ENVIRONMENT PROTECTION ACT 1970

## WORKS APPROVAL APPLICATION ASSESSMENT REPORT

<b>Application No.</b>	1002191
<b>Applicant Name</b>	Landfill Operations Pty Ltd
<b>Address of Premises</b>	408-546 Hopkins Road, Truganina, 3029 and 1154-1198 Christie's Rd, Ravenhall
<b>Proposal</b>	Disposal of municipal solid waste, Category C contaminated soil and solid and inert waste.

**Figure 26: Groundwater level projections**

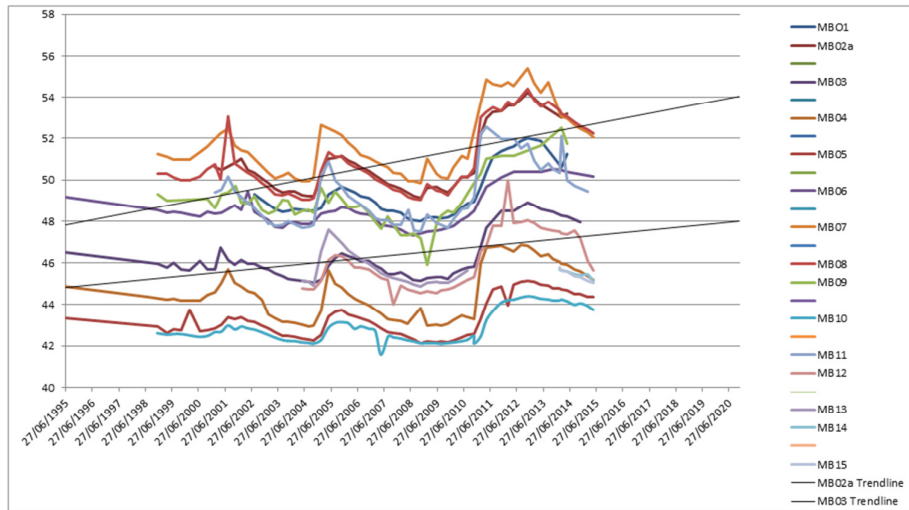
- 4.173 Figure 26 presents groundwater elevations of monitoring bores on the site with greater than 10 years of data available over time. As monitoring bores in the vicinity of the extension are relatively new, they do not have sufficient data available to be presented in this figure. Assuming all other factors remain constant, linear progression (trend lines) for two monitoring bores; MB02a and MB03 have been extrapolated to 2020 (Figure 26). These bores were selected as they are on the western boundary of the current landfill operations and closest to the extension area.

- 4.175 As stated in paragraph 4.171 above, over 200ML of groundwater amount has been extracted over a 4.5 year period January 2012-June 2015 and the allocation appears to have been increased up to 400 megalitres per year. It is not known how much has been extracted from the increased allocation. However, it is considered reasonable to expect that the water level measurements recorded and shown in Figure 23 and Figure 24 may have been affected by groundwater extractions. At least some of them should have been affected by groundwater pumping depending on the zone of influence of groundwater pumping bores. Despite this, water levels measured in April-May 2014 have been considered in the WAA as representative for long term undisturbed water levels without considering the impact of groundwater extraction.

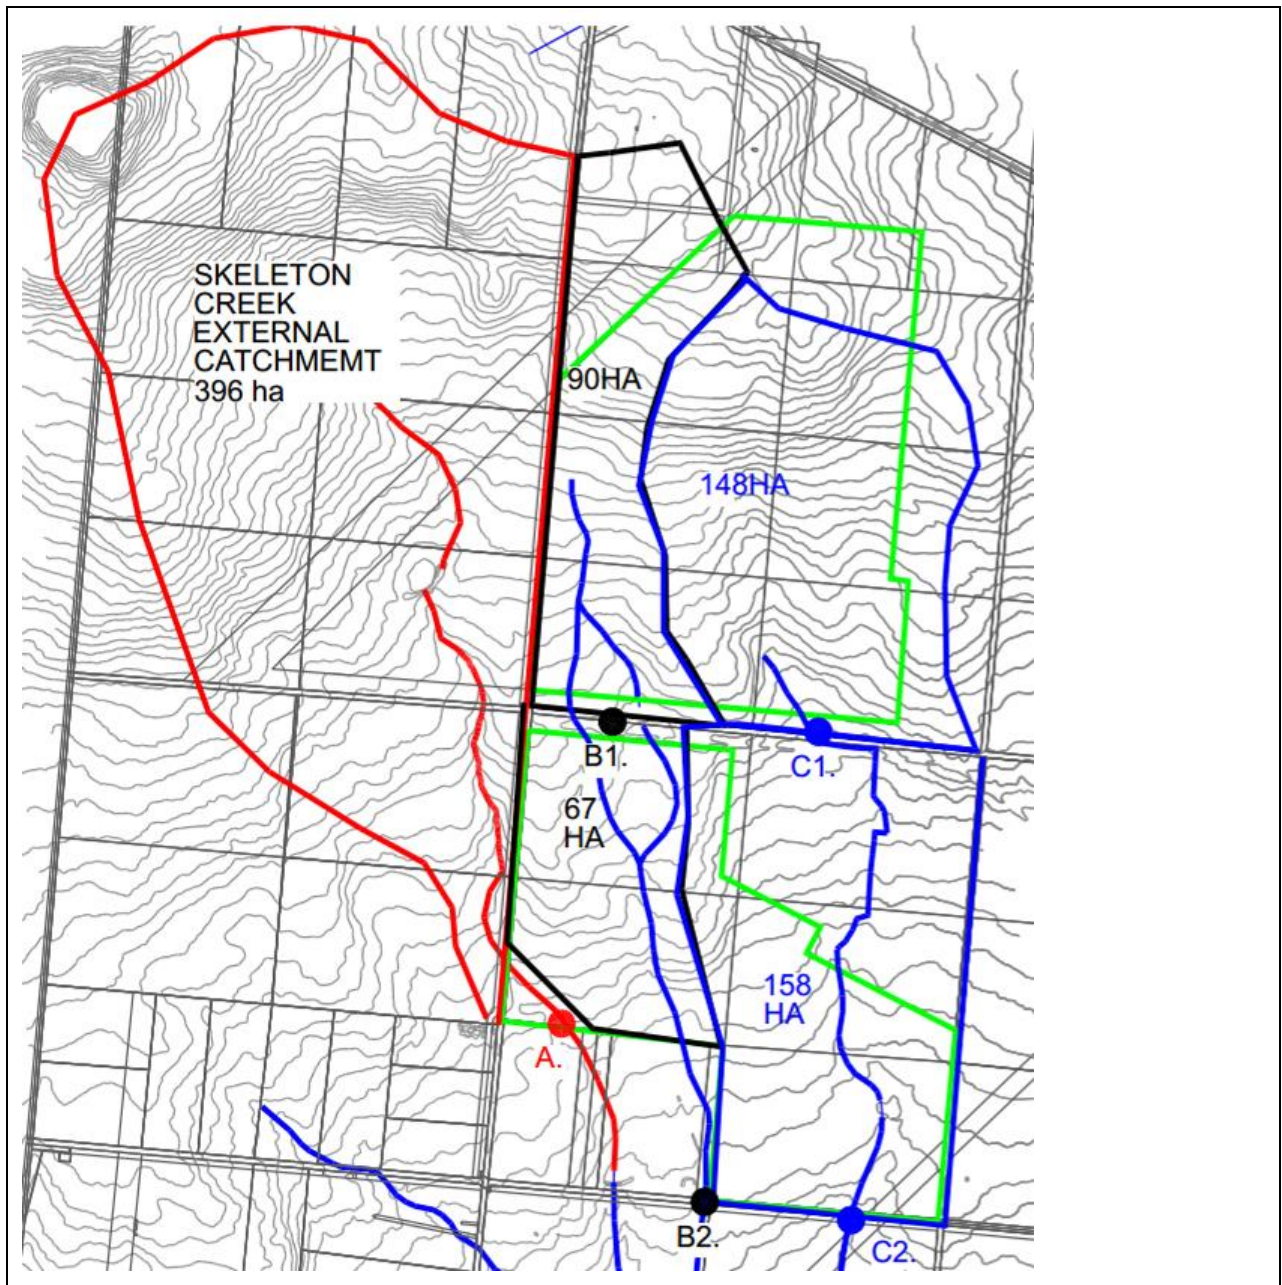
In relation to internal catchments, Figure 1 defines what was on the ground before any development of the site. The catchment area of the tributary to outfall point C2 is largely located within areas affected by an existing quarry. A large portion of the catchment to B2 may not be affected by the existing quarry. However, it is understood (EPA meeting held on 10/2/17 and Boral Quarries Plan VQ17-21-5, September 2001, detailing extraction limits and buffers) that it is affected by agreements assuming the quarry will affect this catchment.

It is considered that it would be beneficial for an "existing" catchment plan to be developed to clearly delineate and define "existing" catchment discharging at surface to Points B2 and C2. The "existing" condition would account for the previously agreed quarry development. In this way any changes to existing offsite impacts (from those previously agreed) could be assessed. This is a usual step in any SWMP development.

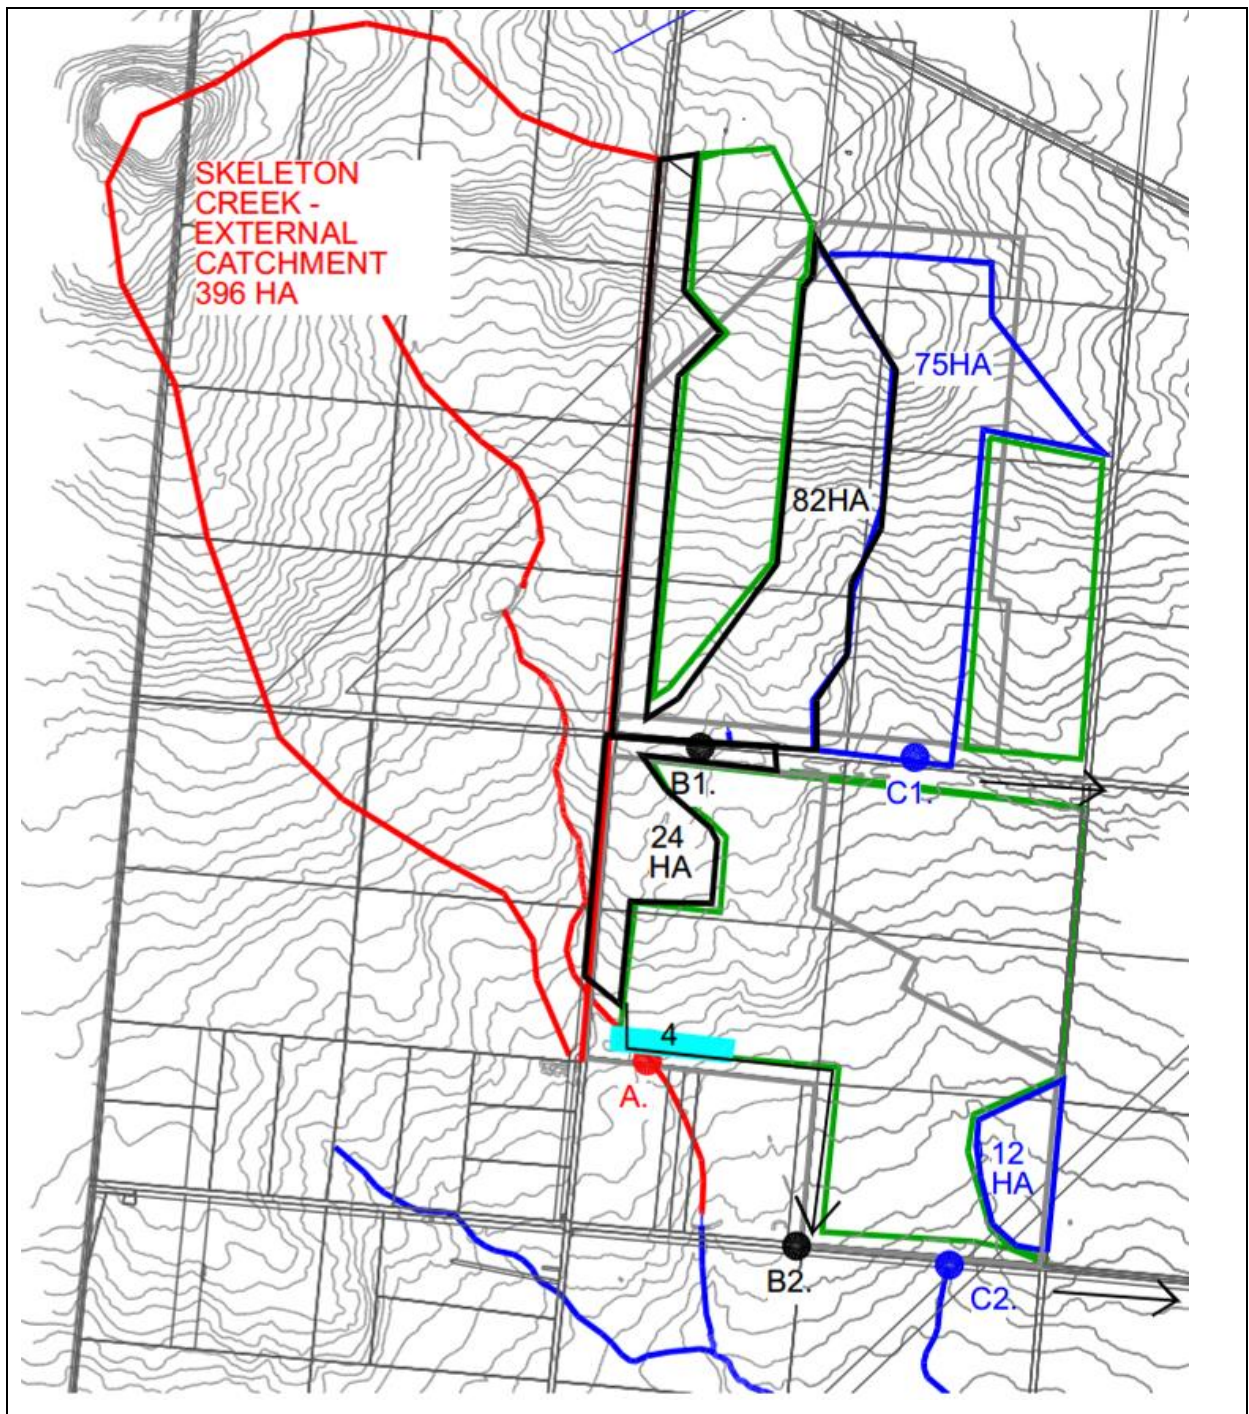
In the EPA meeting of 10/2/17, the proponent indicated that, although stormwater from discharge ponds is defined as discharging off site, some discharge ponds will in fact be discharging to storage ponds (thus retaining stormwater on site). As such, Figure 2 is not completely correct. This misunderstanding

The “MRL Ravenhall, Truganina DSS Plan, 14/9/16” appears to show discharge from the landfill site being directed to outfall points B2/C2 and not east as in previous versions. However, a small undefined blue arrow is still indicating some flow east into an adjacent catchment. In the EPA meeting of 10/2/17, the proponent indicated that all site flow will be directed south. This must be clearly shown in future versions of the SWMP.

4. The proponent should produce an overall post development catchment plan (similar to Figure 2) to adequately delineate catchments discharging stormwater offsite, future outfall point and catchments discharging to storage ponds (resulting in no stormwater discharge off site).

**Figure 3 Skeleton Creek in Relation to site proposals**

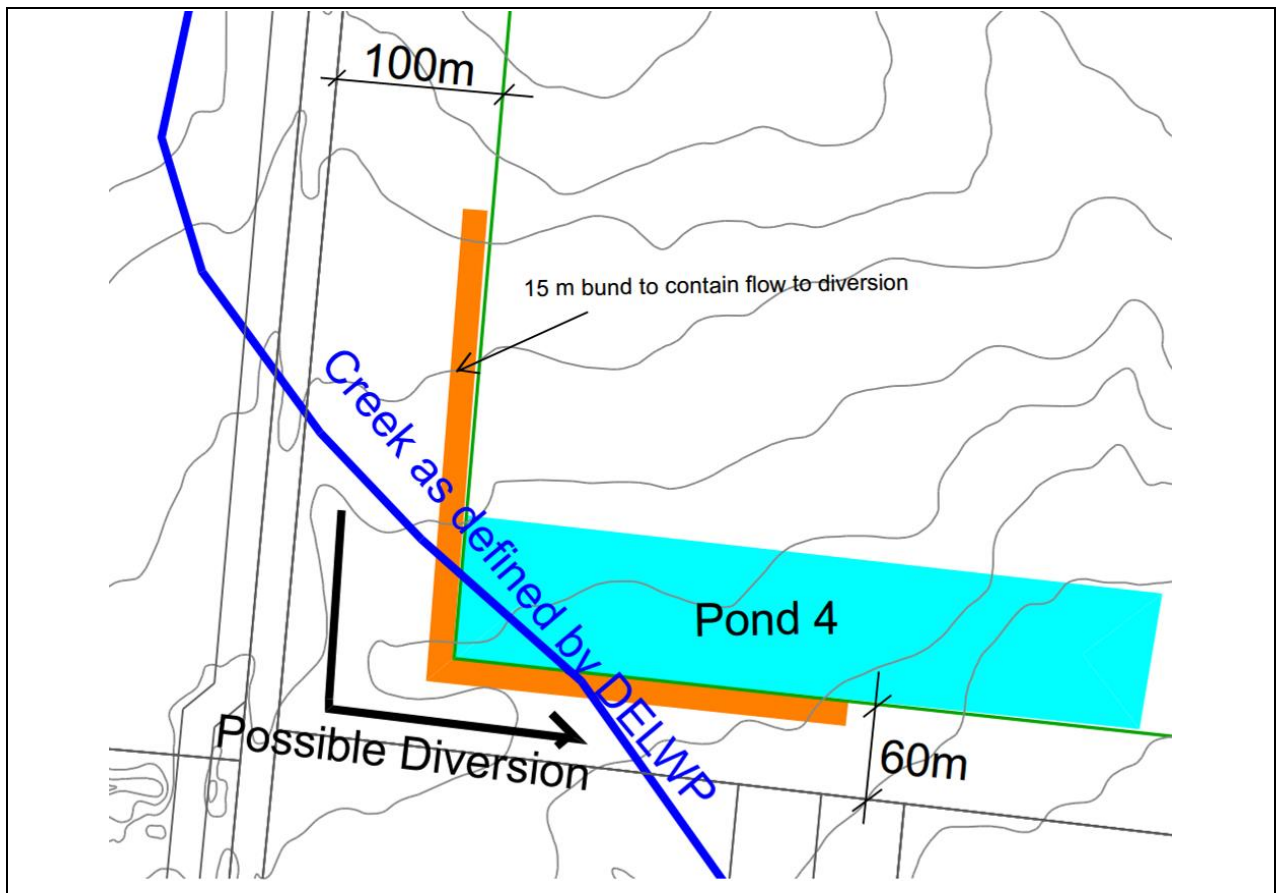
Figure 3 is an attempt to clarify the original SWMP site proposals. As detailed the existing DELWP waterway alignment appears to clash with the quarry wall and Pond 4. Obviously a diversion of the waterway is required. To achieve this both a formed waterway and a bund (to ensure flow does not enter the quarry) are required between the property boundaries and the defined buffer line. About 15 meters will be required for the bund if it is assumed to be about 1 metre high, with 1 in 5 batters. Along the southern boundary this leaves 45 metres for the waterway formation.

**Figure 4 Schematic cross section of drainage assets constructed on a traverse requiring land take in addition to the flood water “top width”**

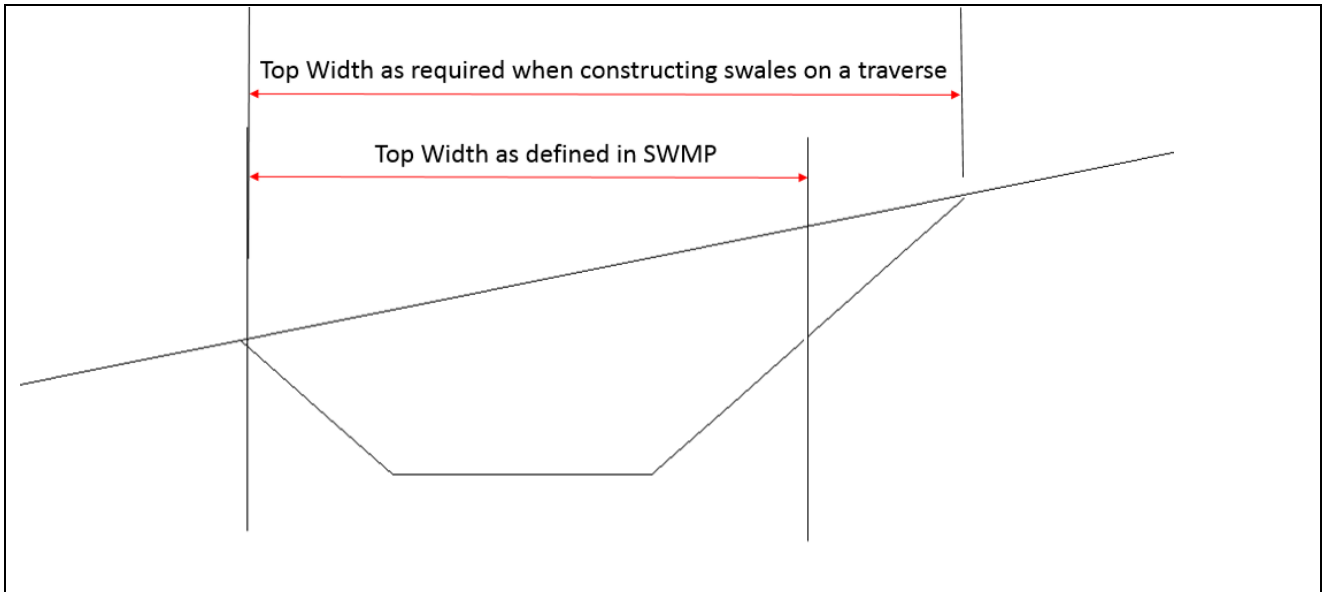
In regard to the swales (both inlet and outlet) they will need to be constructed on a traverse slope in the order of 1 in 10. As detailed in Figure 4 below this adds to the total width requirement of the asset. If vegetated swales are utilised, SWS preliminary calculations indicate that this could result in swales in the order of up to 12 metres wide being required in some locations.

Figure 5 Reproduction of SWMP Plate 2 “Conceptual Cross Section of Discharge Pond”

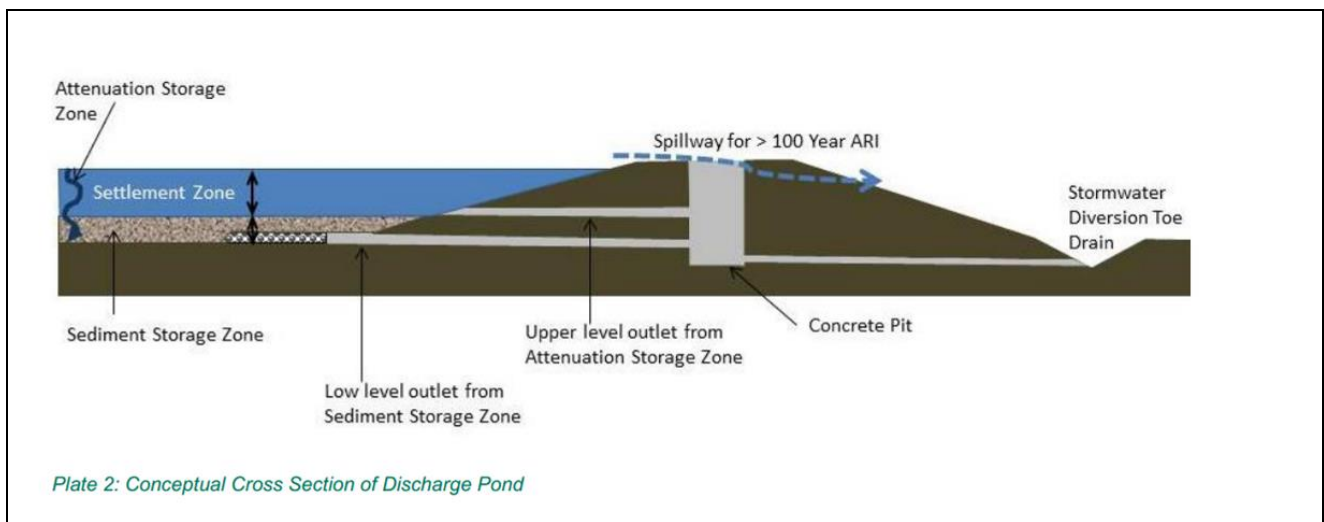
In regard to the general configuration detailed in Figure 5, the low level outlet (and gravel seepage collection pads with a perforated small diameter pipe constructed at the base of the ponds) may not be required. This system base and outlet pipe will be prone to blockage, asset pipe damage during cleanout etc. As detailed in the current Melbourne Water Recommendation (Figure 6), a sediment accumulation zone can be a pond, and does not need to dry out. MWC sediment ponds do not usually incorporate low level outlets from the sediment deposition area.
